From: FREGONESE, Victor <vxf@nei.org>
Sent: Wednesday, April 26, 2017 2:23 PM
To: Drake, Jason
Cc: Morton, Wendell; Rahn, David; GEIER, Stephen; REMER, Jason
Subject: [External_Sender] NEI Comments on Draft RIS and Draft Qual Assessment Guidance
Attachments: Draft_RIS_to_Clarify_RIS_2002-22_04-20-2017 Meeting Copy [NEI Comments 4-26].docx; Qualitative Assessment Guidance 04-20-2017 Public Meeting Copy [NEI Comments 4-26].docx

**NRC REGULATORY ISSUE SUMMARY 2017-XX
UPDATE TO THE STAFF ENDORSEMENT ON THE USE OF
EPRI/NEI JOINT TASK FORCE REPORT,
“GUIDELINE ON LICENSING DIGITAL UPGRADES: EPRI TR-102348,
REVISION 1, NEI 01-01: A REVISION OF EPRI TR-102348 TO
REFLECT CHANGES TO THE 10 CFR 50.59 RULE”
(REPORT PREVIOUSLY ENDORSED **BY WITHIN** RIS 2002-22)**

Draft – Qualitative Assessment Framework

Figure 1 - RIS Decision Tree Flowchart

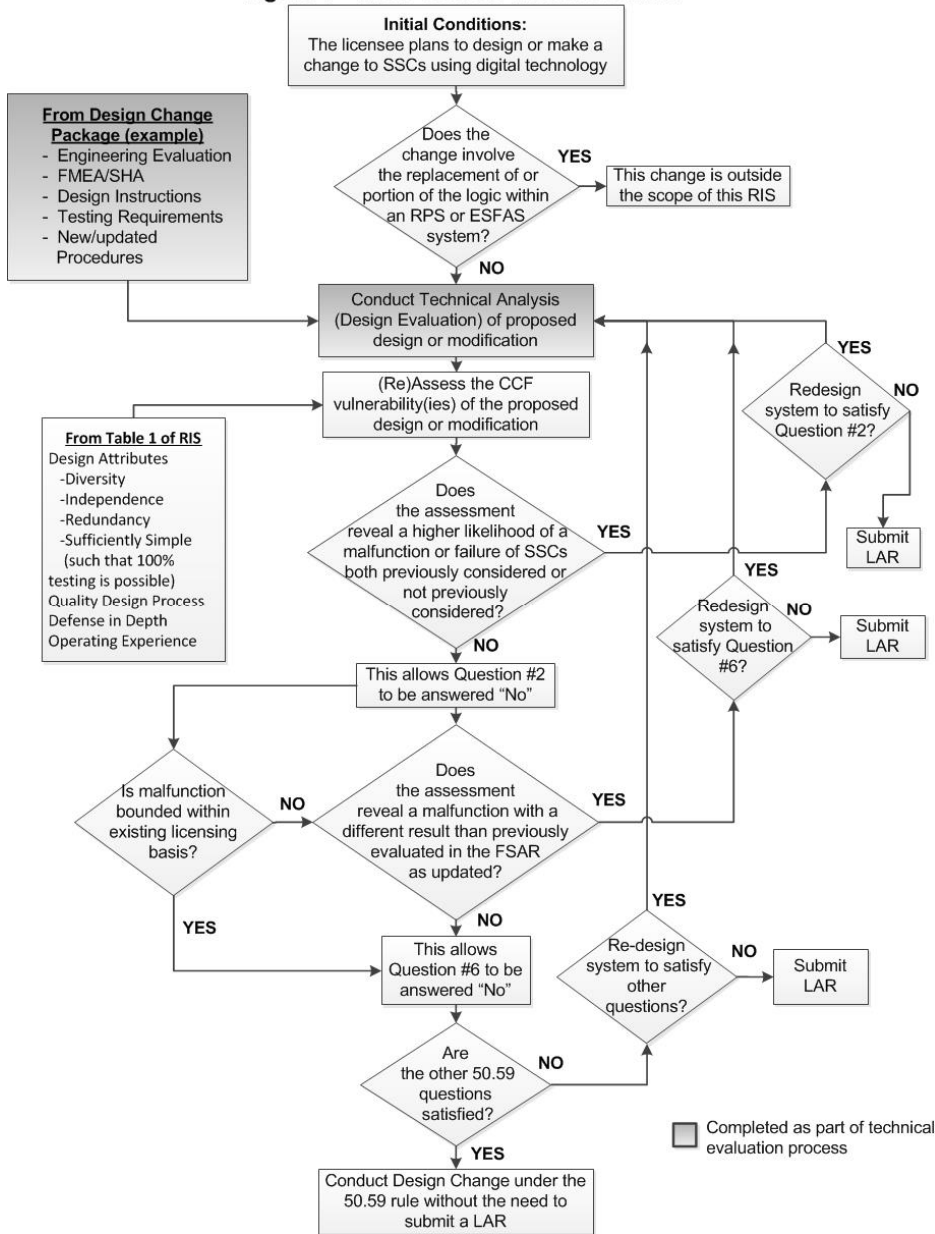
Commented [vxf26]: There is no box for 50.59 Question #6.

Commented [vxf27]: Many of the "rectangles" on the flow chart do not have a "yes" or "no". For instance, the box that contains "This allows Question #2 to be answered NO". Please clarify this in the flowchart.

Commented [vxf28]: Please refer to previous comment on the 100% testability in Table 1.

Commented [vxf29]: Please clarify what the purpose of the decision block that states: "Is malfunction bounded within the existing licensing basis?"
